# **Development Facilitation Team (DFT) – Review Comments**

DRB Project No: PR-2023-008364 Date: 04/12/2023 Agenda Item: #6 Zone Atlas Page: (R-15, S-14,

### Application For: SD-2023-00084--PRELIMINARY/FINAL PLAT (DHO) Sketch Plat 3-15-23 (DFT)

**REQUEST:** REPLAT OF TRACT 6 BULK LAND PLAT TO CREATE TWO TRACTS, 6A AND 6B

#### \*Previous sketch plat from March of 2023.

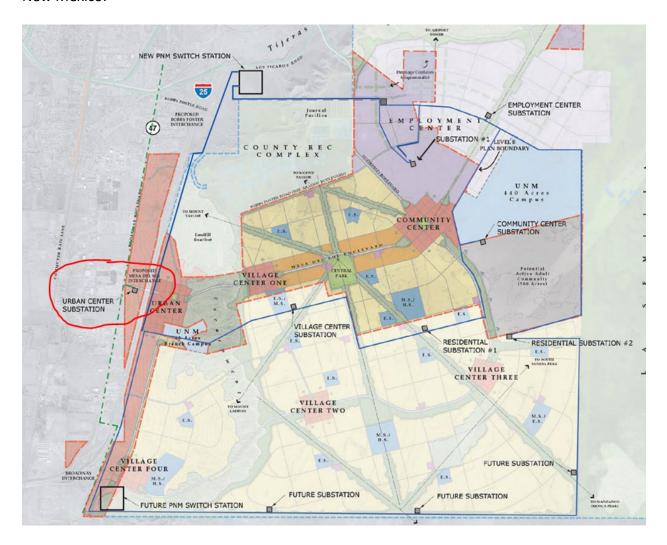
- The proposed replat has been determined to be a Minor Preliminary/Final Plat.
- All development and platting actions are subject to IDO section 5-4-C (Subdivision of Land Compliance). Action cannot increase any existing nonconformity or create a new nonconformity. \*Plans should demonstrate compliance of these standards.
